Access Compliance Report

Public Rights-of-Way

(Curb Ramps)

Intersection ID: 7131	Main Street: N_TRYON_ST	Cross Street: ORCHARD_TRACE_LN	Location: NE
ADA ID: 27575540CDBA	Ramp Type: Perp	Initial Pass/Fail: Pass	Overall Compliance: No
Severity Score: 5			
Codes/Mitigation Info/Possible Solution		Field Measurements/Component Compliance

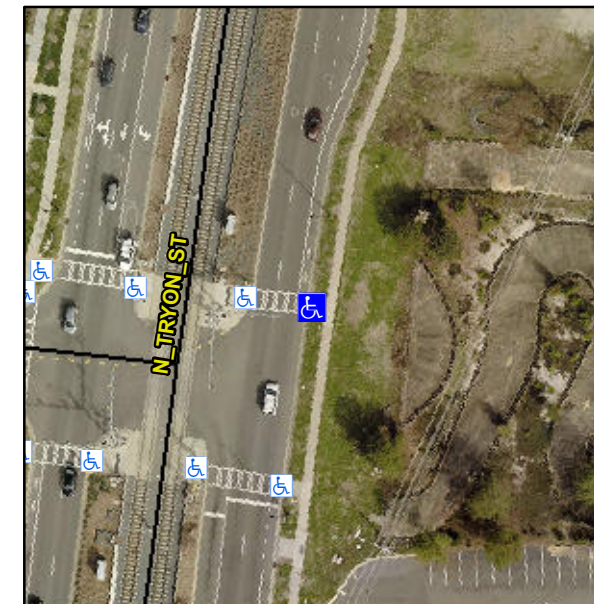
R302.7, R304.5.4

Remove & Replace Gutter.
